Victorian EDPR 2021-26 – online public forum

To assist stakeholders in accessing all responses received to the questions submitted as part of the online public forum, the Australian Energy Regulator (AER) has collated all the responses into this one document. The responses received in their original context have been uploaded on the AER Victorian EDPR 2021-26 public forum [webpage](#).

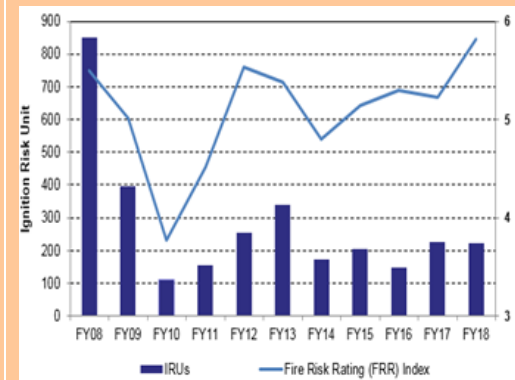
<p>EUAA (from public forum presentation)</p>		<p>How does AusNet see its trend total/capex/opex productivity and performance against its peers trending if the AER accepts its 2022-26 proposal as currently presented? (slide 5)</p>	<p>While relative productivity will depend on a range of factors including the performance of the other businesses, and what costs are included or excluded (but customers still pay for) our proposal has several elements that will help improve our productivity vis-à-vis our peers. For example, we have committed to absorbing numerous additional opex costs within our regulatory base, contributing to an annual productivity saving of over 1%.</p>

<p>As outlined above, we have the lowest opex (no exclusions) per customer of all rural distributors. Therefore, on the metric of what customers actually pay, we perform well.</p> <p>This is not readily apparent from the AER’s benchmarking analysis as the economic benchmarking embeds historical differences in networks’ capitalisation policies and does not always reflect the opex customers actually pay.</p> <p>We note that the AER has committed to reviewing its approach to different capitalisation policies and how to include bushfire risk as an operating environment factor. These issues, when addressed will provide greater transparency on our absolute and relative efficiency.</p>
	<p>Consumer engagement</p>	<p>What form will consumer engagement take from now on given the Customer Forum is finished? (slide 6)</p>	<p>AusNet Services’ consumer engagement will take several forms, including:</p> <ul style="list-style-type: none"> ▪ Continued use of the AusNet Services’ Customer Consultative Committee (CCC); ▪ For this reset, discussions on a one-one basis, noting that we have we have used this approach already, including with the CCP-17 and EUAA/ Brotherhood of St Lawrence; and ▪ Continued customer research and increased grass roots engagement and listening (a reflection of the cultural change that has occurred within our businesses). <p>The benefits of this can be seen in our much-improved responses to customer needs during the Bushfire emergency over the Summer and the current COVID-19 crisis. This has included relief and support payments, temporary generation and further investment in community resilience.</p>

<p>We are also considering the lessons learnt from trialling the New Reg approach, and will look to capture the most successful elements of this going forward.</p> <p>Finally, we note we will be implementing a Customer Satisfaction Incentive Scheme and several customer experience improvement schemes. We will be held accountable for these as we will be monitored and reported on annually via a public Customer Interactions and Monitoring Report.</p>
Revenue building	<p>What would have been the average price changes for non-residential without WACC and tax alliance changes – to compare with the \$430 or 9% quoted (slide 9)</p>	<p>AusNet Services’ proposal offers price reductions of \$627 (\$2021) for non-residential customers, from an average bill in 2020 of \$4,798. In the absence of the WACC and the tax changes, and the lower expenditures proposed by AusNet Services, there would be an increase of \$669, resulting in an average bill of \$5,467.</p> <p>The total price reduction resulting from both lower expenditures and the WACC and the tax changes is \$1,296 for non-residential customers. Of this, the WACC and tax changes account for \$835, or approximately two thirds of the decline.</p>

Figure 1 CitiPower, percentage of time solar is constrained (showing the impact of DVMS)

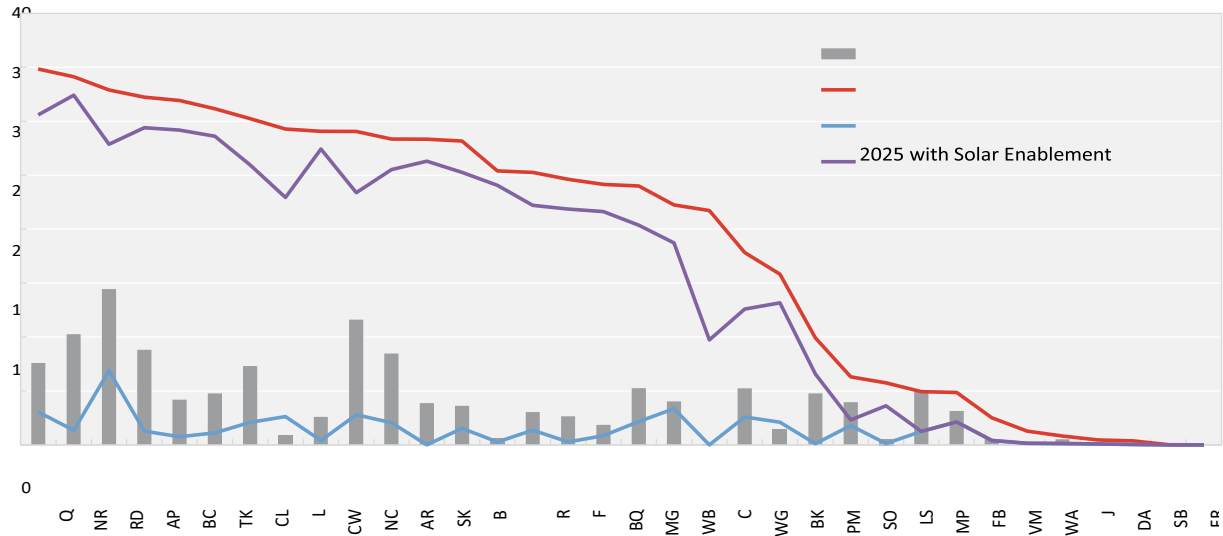
DER Integration	<p>DER integration costs centre almost exclusively on managing voltage rise above legislated limits. Could the distributors comment on analysis that may have been done to implement advanced grid voltage management strategies or even voltage reduction. We also note that some utilities have offered voltage reduction as a demand response or market response opportunity, suggesting voltage reduction is possible. The change in household appliances suggests sensitivity to low voltage may be less than it has been in the past. Have distributors considered the risk and costs of reducing grid voltage and addressing low voltage issues as an alternative or delaying option to investing as widely in customer controls and LV augmentation? Have any trials to do so been considered or undertaken?</p>	<p>Our United Energy network operates a dynamic voltage management system (DVMS) and we have proposed to implement this in the CitiPower and Powercor networks as part of Solar Enablement. This solution, both remotely and dynamically, changes zone substation voltage set points. This means at times of high voltages, it will reduce the voltages of every customer on that zone substation and vice versa at times of low voltages. More information is available in our business cases—for example see PAL BUS 6.02, section 5.2.2, B.1.5 and appendix C.</p> <p>As pointed out in the question, we currently offer this type of service for demand management. The key difference is we will now be automating the process with our DVMS to replace the current manual process. A manual process is reasonable for demand management given we only provide this service for a few critical hours per year at particular zone substations. To enable solar however we will need to provide this service network-wide and continuously.</p> <p>We would like to clarify that CitiPower, Powercor and United Energy’s solar costs are not centred on managing voltage rise to be within legislated limits. Our costs are centred on customer impact. That is, we are seeking to remove instances of voltages reaching the voltage point at which inverters automatically trip off and stop producing solar, at which point all customers lose the benefit of solar generation. We performed a cost benefit analysis to remove constraints based on the value of enabling solar to customers i.e. where the benefits all customers receive exceed the cost removing the constraint.</p> <p>In our business case we point out that code compliance is not a standalone identified need because it could lead to untenable and uneconomic outcomes. For example, meeting the Code</p>

<p>requirements with respect to solar could be achieved by restricting all exports or allowing all exports and undertaking significant (and uneconomic) network investment.</p> <p>Both of these options are a simplistic view that does not take customer preferences into account. Therefore we consider any approach to enabling solar should contribute towards, rather than detract from our Code obligations—particularly given these obligations are in place to protect customers from poor supply quality—but not target Code compliance as the primary outcome.</p>
	<p>DER Integration</p>	<p>Both the ECA and CCP17 have carried out some broad-brush analysis regarding the cost of integrating Distributed Energy Resources. This is useful analysis, and we appreciate the ECA also exploring this area.</p> <p>It is difficult to draw a conclusion as to the actual cost of DER integration as the costs are often spread across a number of categories (Augex, ICT capex, opex, innovation, LV remediation).</p> <p>Whilst the findings draw similar conclusions, we note some differences in the output of the analysis. CCP17 is happy to share the calculations behind our analysis.</p> <p>Our questions are:</p> <p>a) Could ECA share their analysis to help understand the different analytical approaches taken by ECA and CCP17?</p>	<p>We consider that the total cost of managing solar should be considered in an analysis of solar costs rather than only the costs over a single regulatory period. SAPN's and Energex's growth in solar occurred predominantly over the period 2015-2020 and they were funded over that period to support that growth. In contrast, we've been managing solar without any regulatory allowance to date. Going forward, we face increasing demand for solar driven by Victorian Government incentive programs that will see similar levels of solar penetration seen by SAPN, particularly in the Powercor network, by 2026. That means the full costs of bridging the gap between current and expected demand for solar will be incurred over the next regulatory period.</p> <p>It is also important to consider the different outcomes of distributors' solar programs. Our solar program delivers:</p> <ul style="list-style-type: none"> • 5KW export capable connections connection (with some exceptions for customers on SWER) • remove 95% of solar constraints. <p>Powercor is unlocking 423 kWh of solar per customer per annum at the end of the regulatory period, which is more solar than</p>

<p>b) Could the utilities comment on the findings?</p>	<p>outlined by other distributors.</p> <p>Considering distributors' future network programs more broadly, which include IT costs and operating costs for solar, electric vehicles and operating the network more efficiently in the face of change, further demonstrates the value of our program. This comparison is shown in table 2 below.</p>
<p>Forecasts</p>		<p>How material is the disparity between the business's load forecast and AEMO forecasts, and what are the reasons for and implications of the disparity?</p>	<p>Our forecasts differ to AEMO's due to methodological differences. A detailed assessment of the differences in our forecasts to AEMO's is provided in attachments CP ATT022, PAL ATT022 and UE ATT022.</p> <p>While we compare our demand forecasts with AEMO's to identify discrepancies, we have found our forecasting approach is more reliable as it takes account of localised network and economic conditions. As the recent maximum demand record shows, some areas of our network are experiencing strong demand growth. We forecast specific demand drivers at each terminal station level to ensure that growth corridors are appropriately captured in the modelling, unlike AEMO that forecast demand based on observed trends in the data at a terminal station level reconciled to state-wide forecasts.</p> <p>An implication of using AEMO's forecasts instead of our methodology would be not capturing growth areas accurately and potentially threatening security of supply in that area.</p> <p>For our 2016-2020 revised regulatory proposal, CIE, Oakley Greenwood and GHD also reviewed AEMO's forecasting approaches and found them to be lacking in a number of aspects. Key areas of concern with AEMO's approach include: AEMO's connection point forecasts fail to incorporate key drivers of demand at the connection point level and therefore do not allow the responsiveness of demand to key drivers to</p>
